**DOCUMENT 00 90 00**  
**ADDENDUM**

**ADDENDUM No.:** 1

**DATE:** March 3, 2023

**RE:** NORTHWOOD TECHNICAL COLLEGE  
RICE LAKE OFFICE RENOVATION  
1900 COLLEGE DERIVE  
RICE LAKE, WISCONSIN 54868  
PROJECT NO. 22039

**M102**

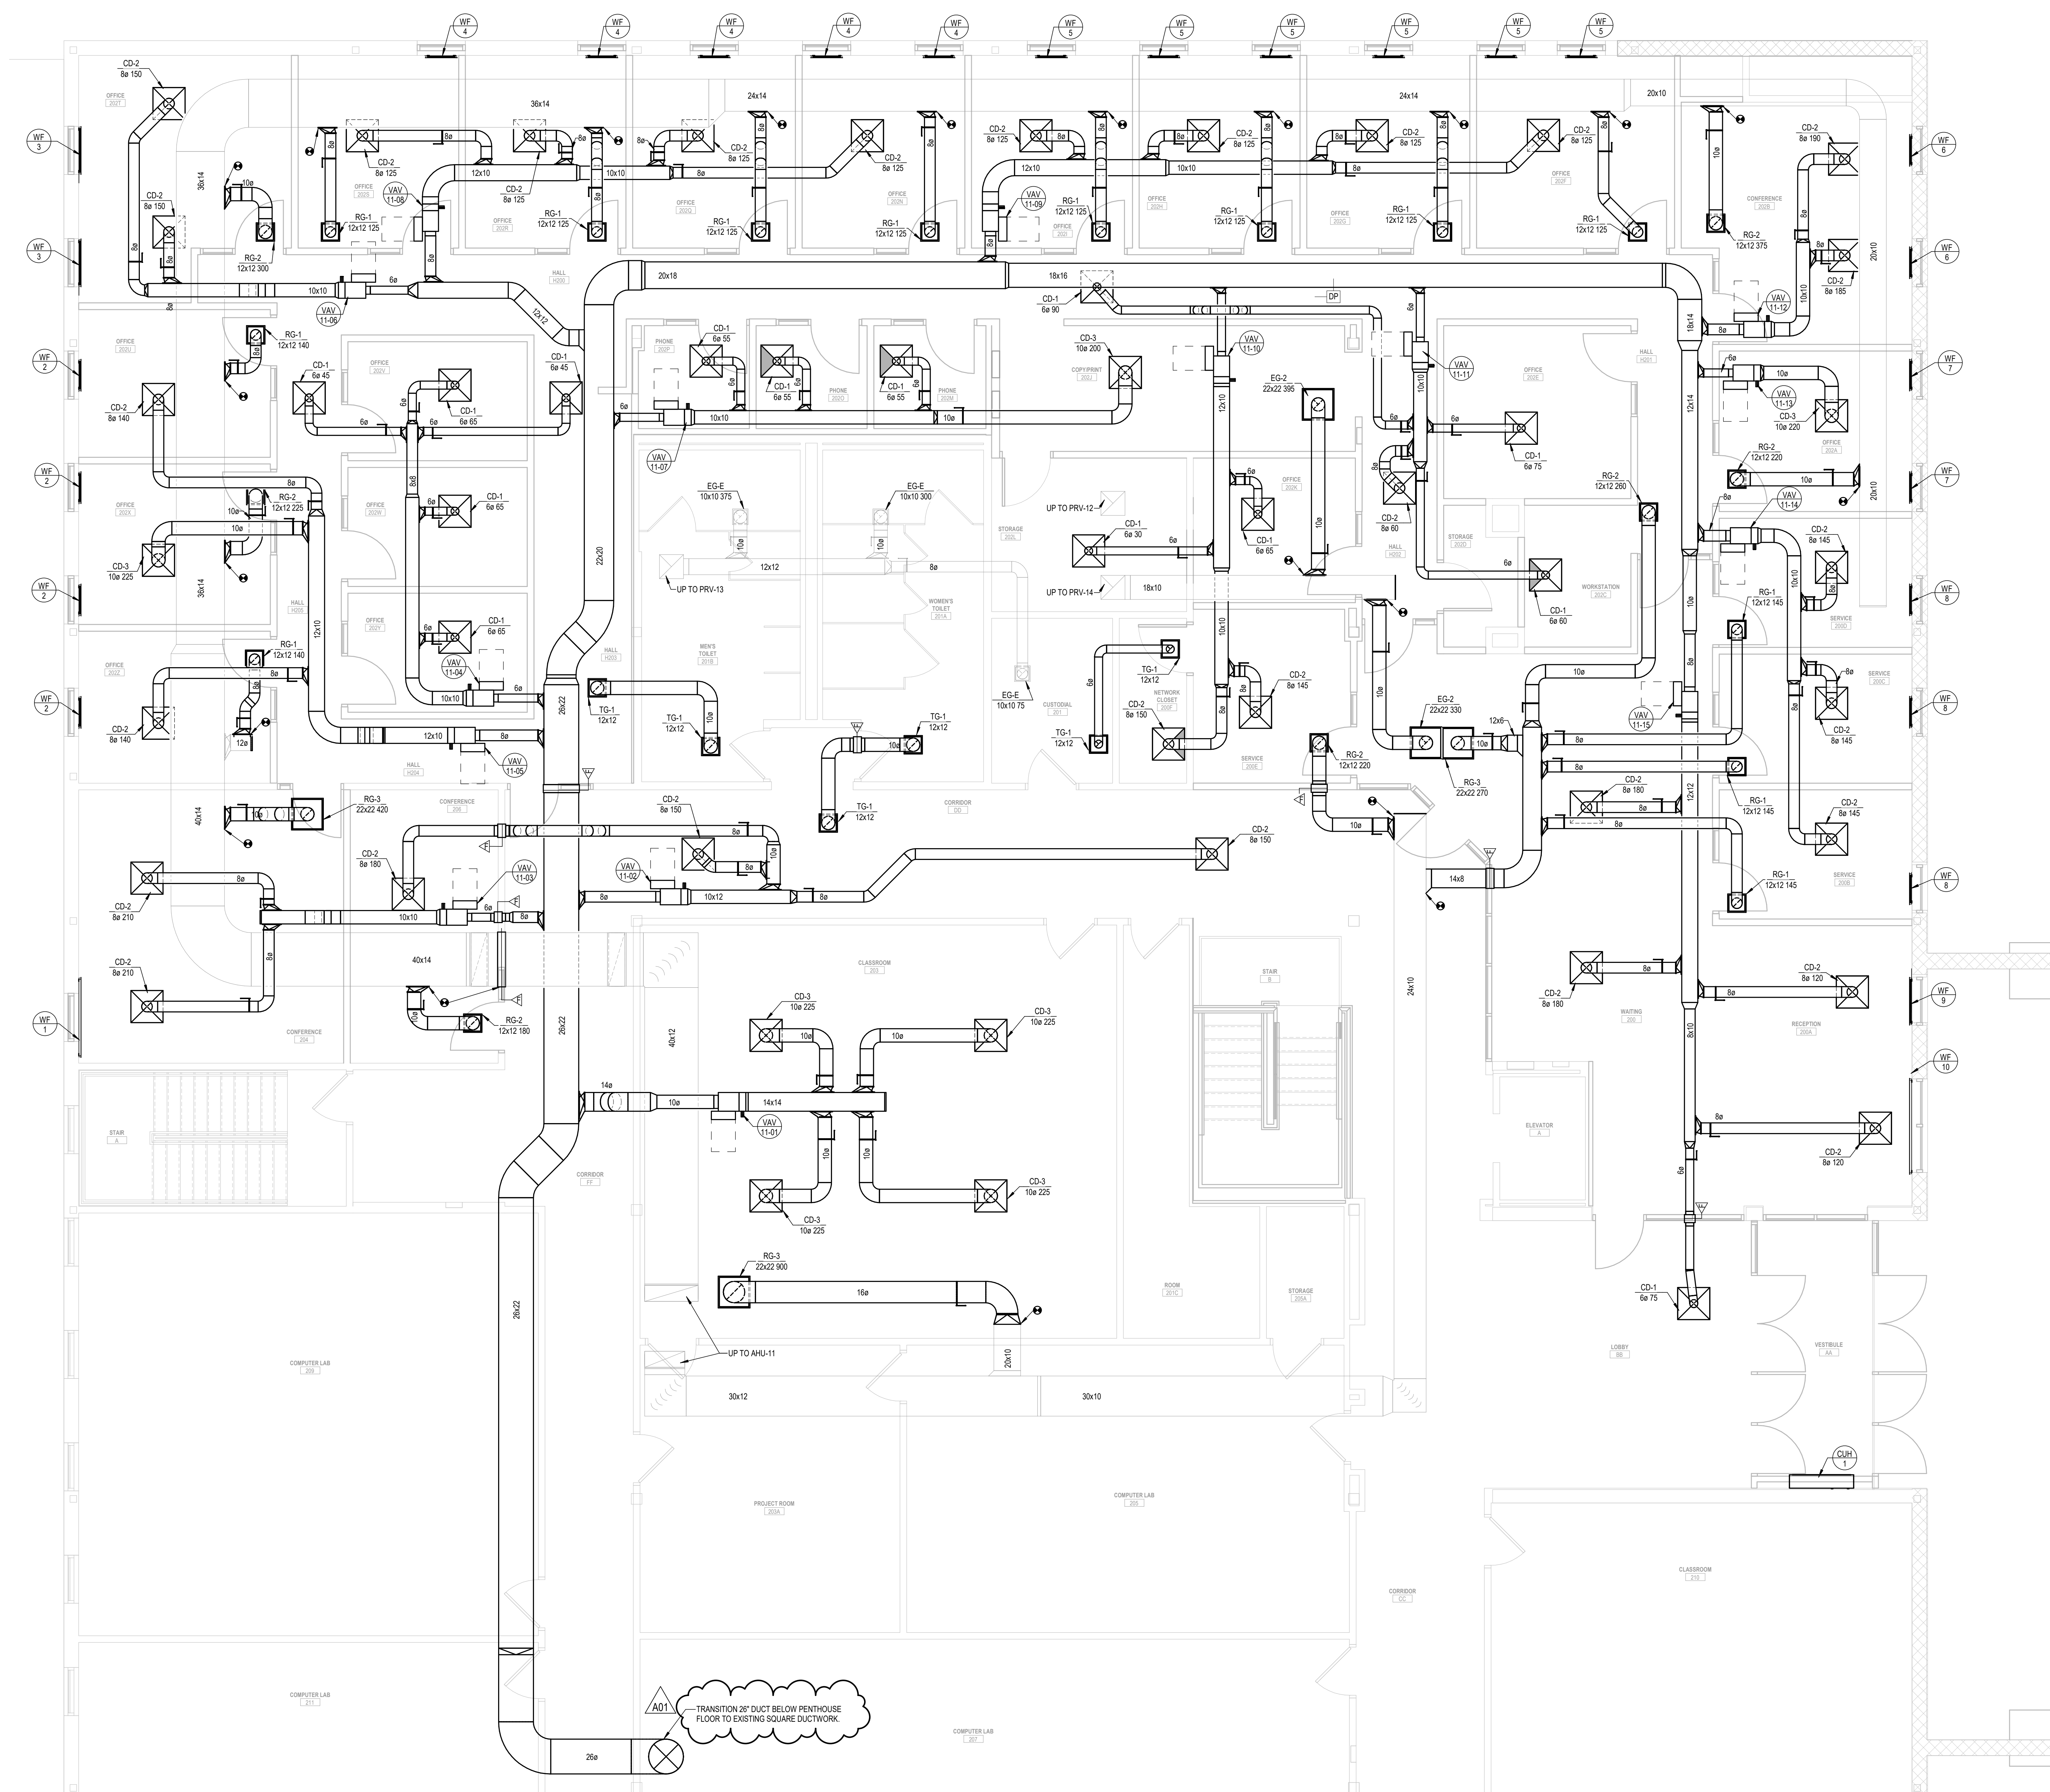
8. Sheet M102 SECOND FLOOR DUCTWORK PLAN 30"x42"
  - a. See the revised sheet included in this addendum. Disregard the previous version.
  - b. Update note on supply ductwork going up to AHU-11.

**MD111**

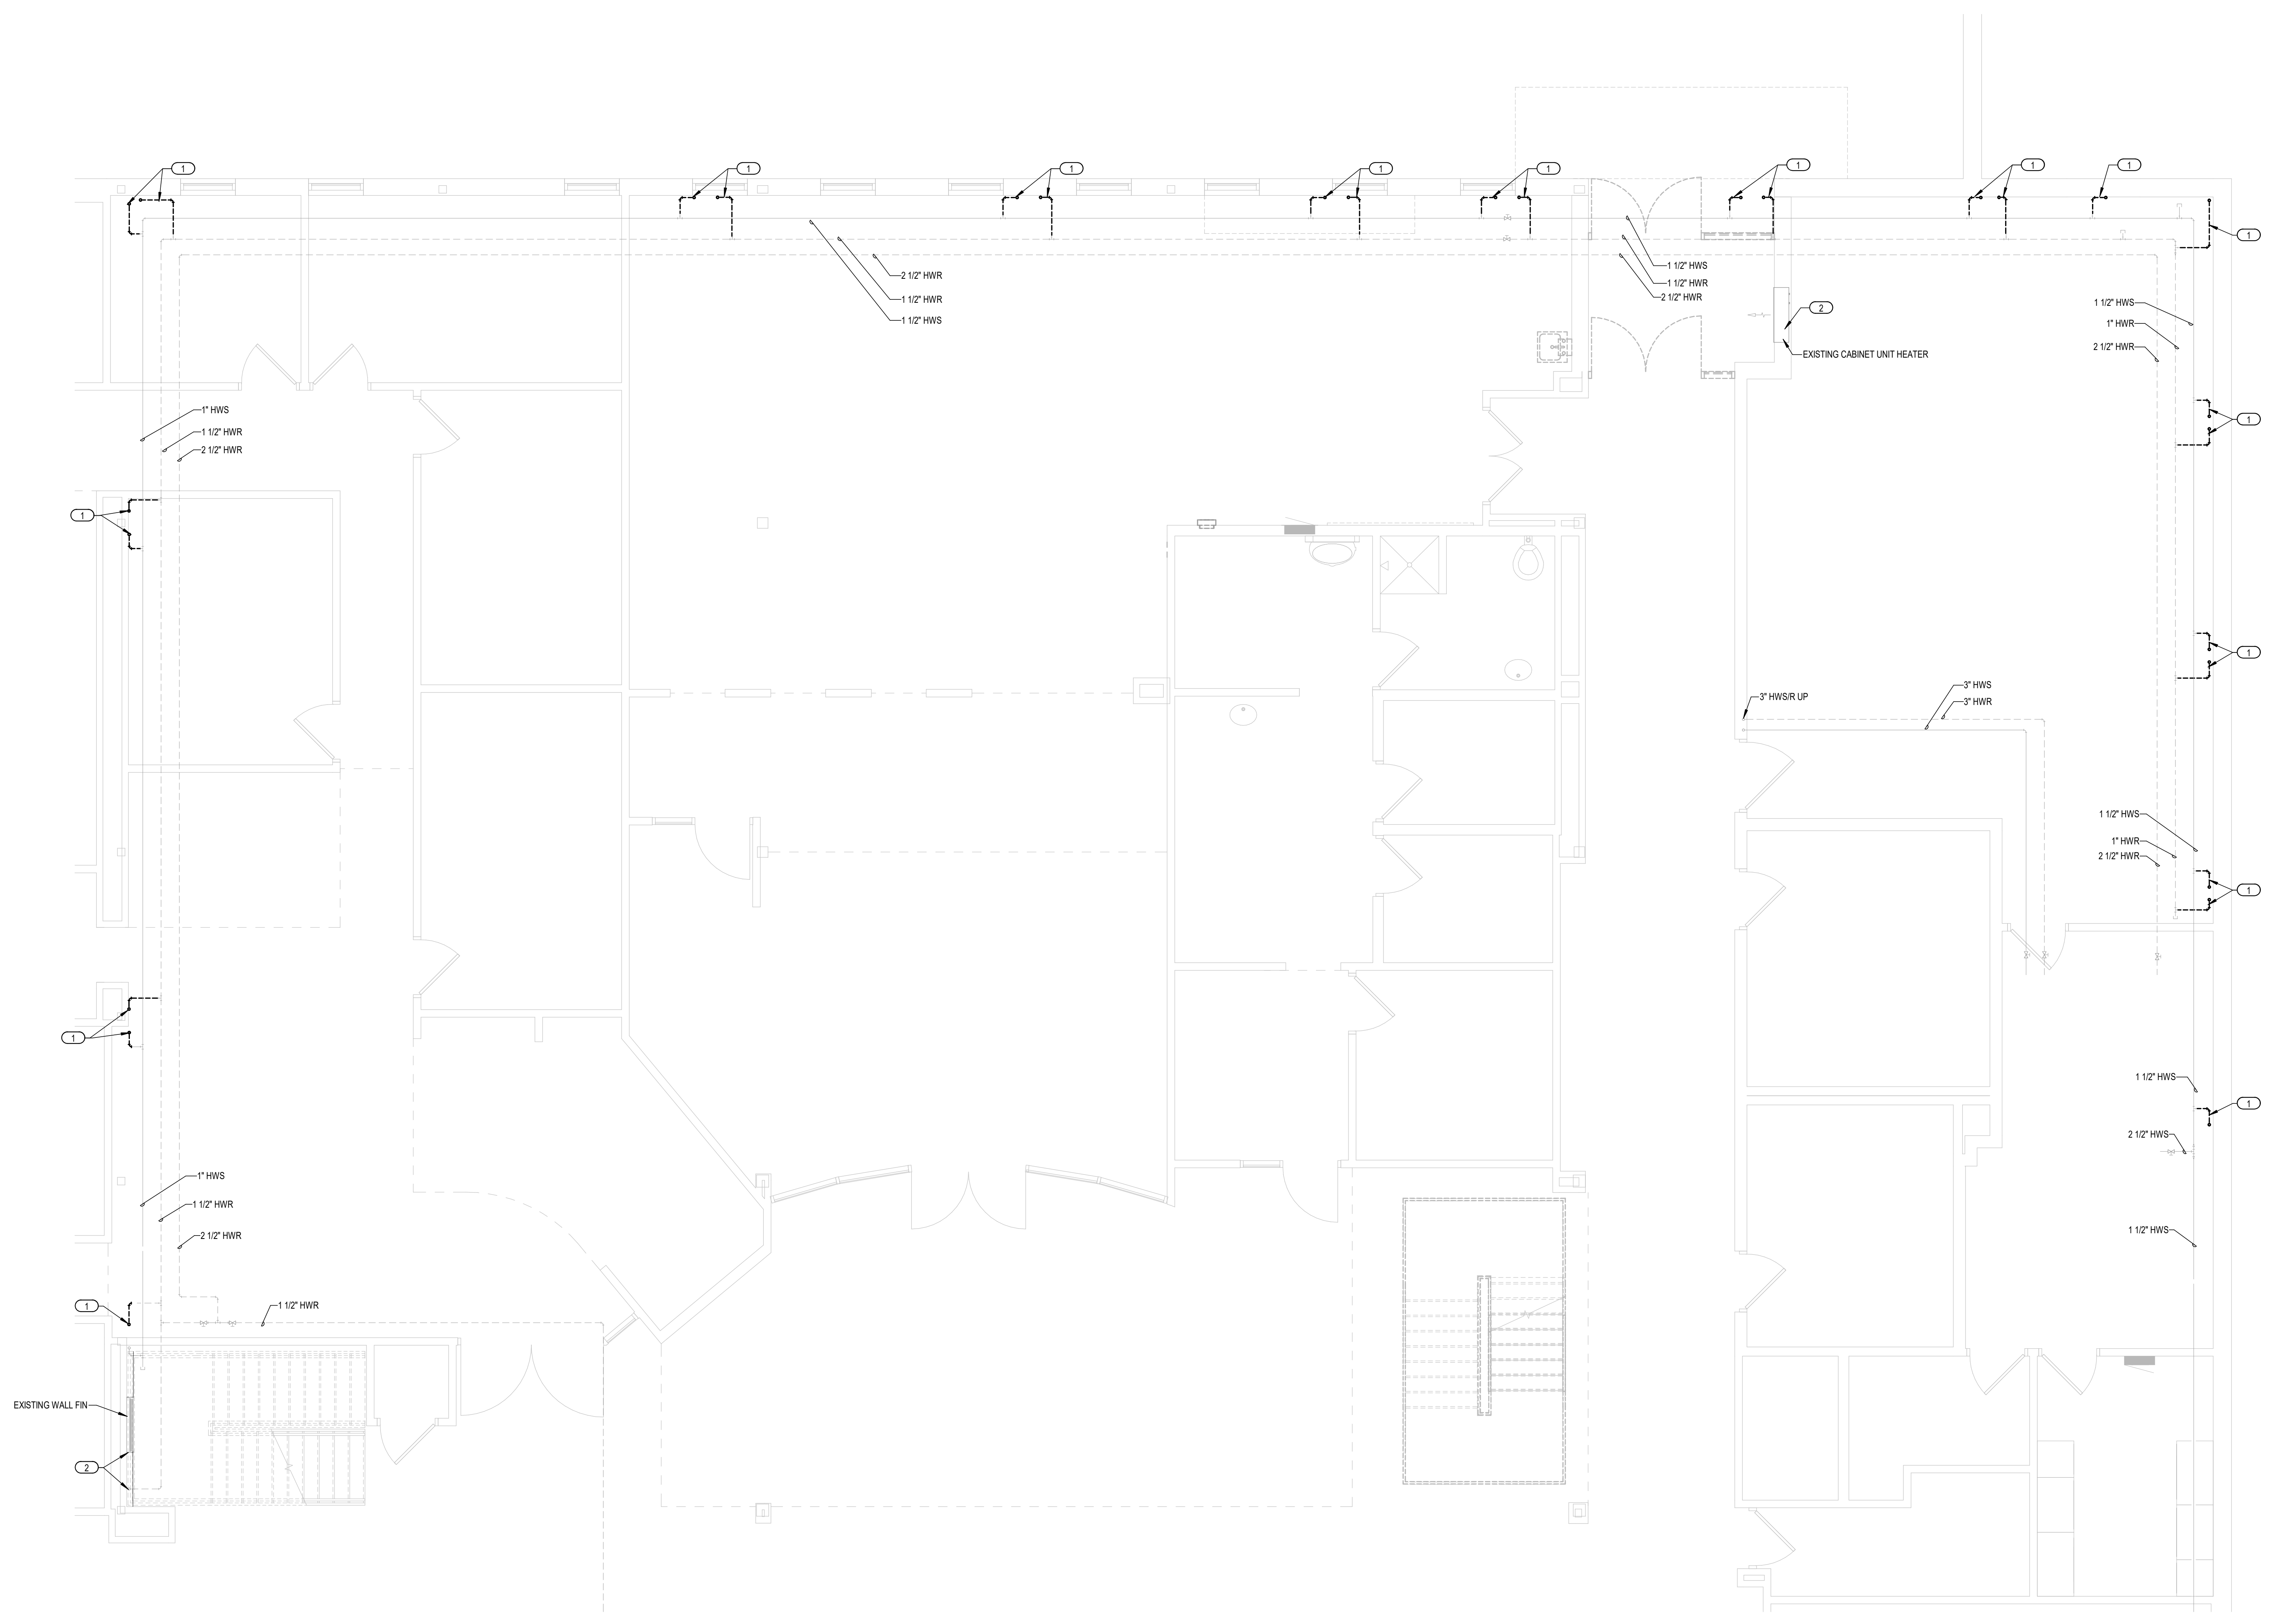
9. Sheet MD111 FIRST FLOOR PIPING DEMOLITION PLAN 30"x42"
  - a. See the revised sheet included in this addendum. Disregard the previous version.
  - b. Add general note for ceiling removal on 1<sup>st</sup> floor.

GENERAL NOTES	KEYED NOTES
<p>A01</p> <p>1. REMOVAL OF CEILING TILE AND/OR GRID FOR DEMOLITION OF EXISTING BASEBOARD HWS/R PIPE BY MECHANICAL CONTRACTOR.</p>	<p>1 REMOVE HOT WATER SUPPLY AND RETURN PIPE AND PIPE SUPPORTS SHOWN DASHED AND IN BOLD.</p> <p>2 REMOVE PNEUMATIC HOT WATER CONTROL VALVE AND ASSOCIATED PNEUMATIC THERMOSTAT.</p>

E103

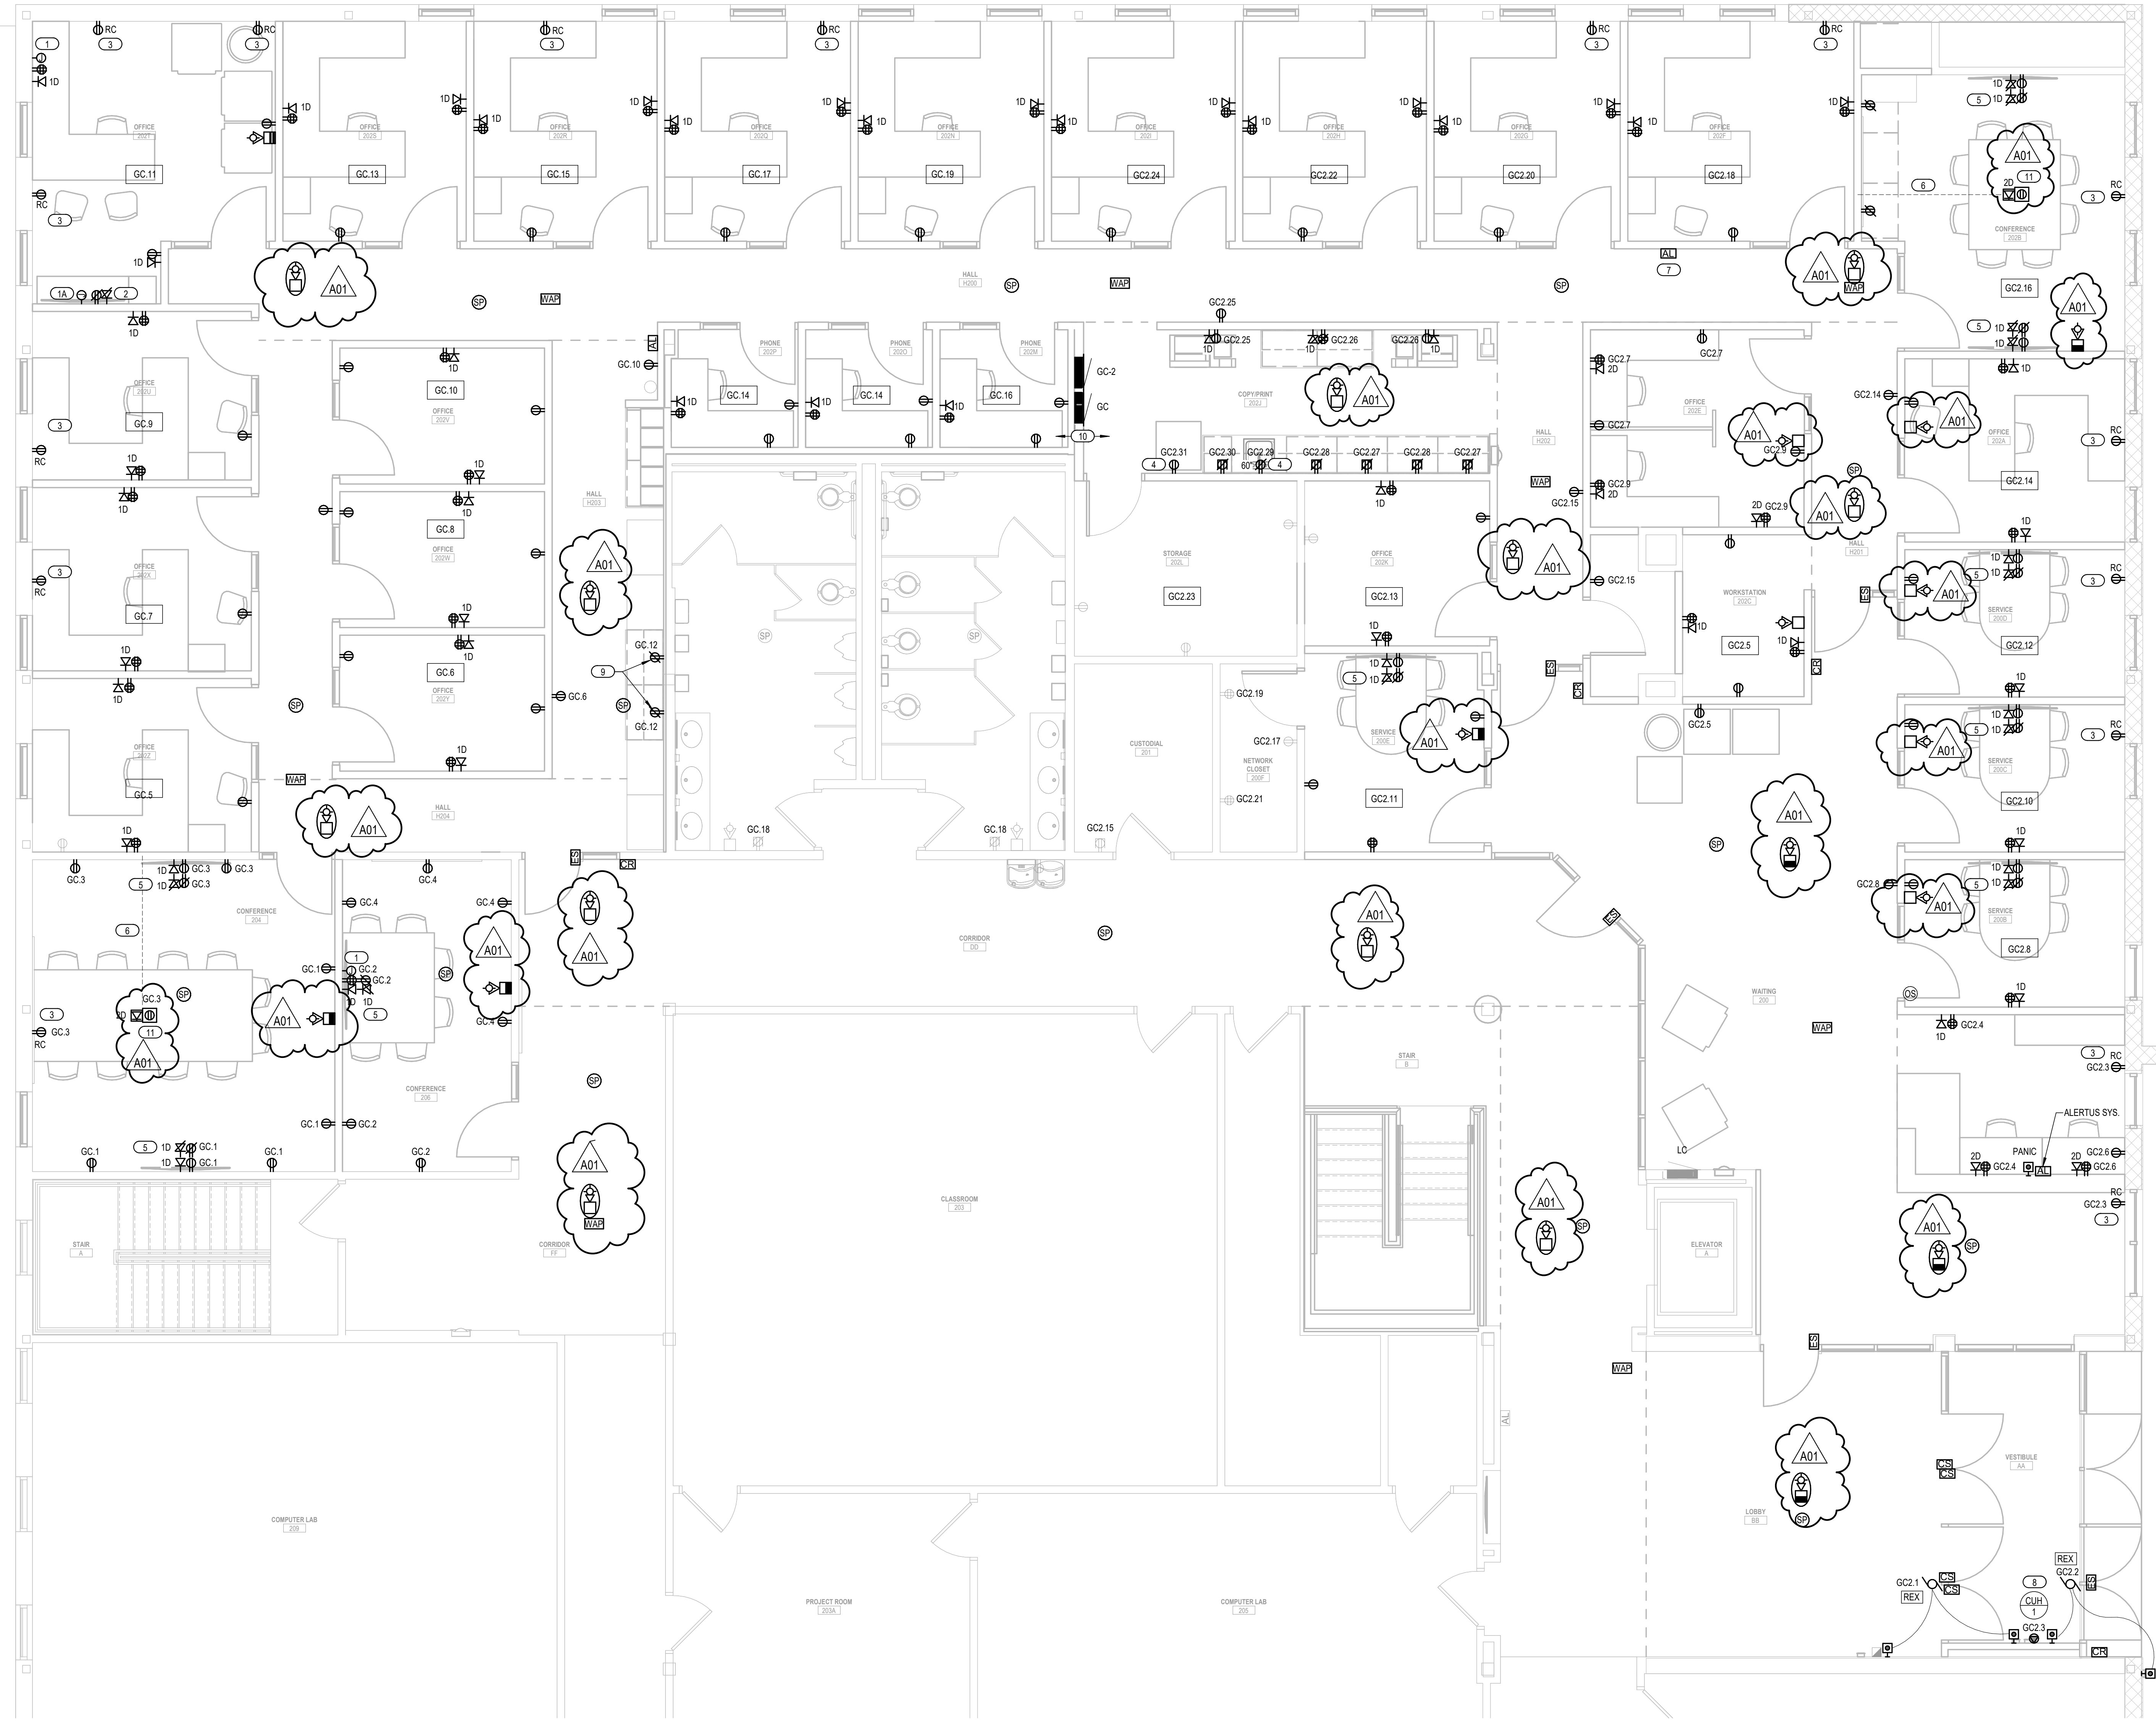
11. Sheet E103 SECOND FLOOR POWER & SYSTEMS PLAN 30"x42"
  - a. See the revised sheet included in this addendum. Disregard the previous version.
  - b. Add fire alarm.

- c. Add Key Note 11 – regarding poke thru device.

- MOUNT RECEPTACLE 6" BELOW UPPER CABINET.
  - REMOVE ALL WORK ABOVE DATA MOUNTING PANELS FROM CONDUITWORK.
  - LEGRAND EVOLUTION IF POKE THRU DEVICE OR SIMILAR. POKE THRU SHALL HAVE MINIMUM OF 2 DUPLEX RECEPTACLE, CAPACITY FOR 8 DATA DEVICES AND SEPERATED COMPARTMENTS FOR VIDEO CABLING. PROVIDE WITH SURFACE STYLE COVER ASSEMBLY. COORDINATE COLOR/FINISH WITH OWNER/ARCHITECT.
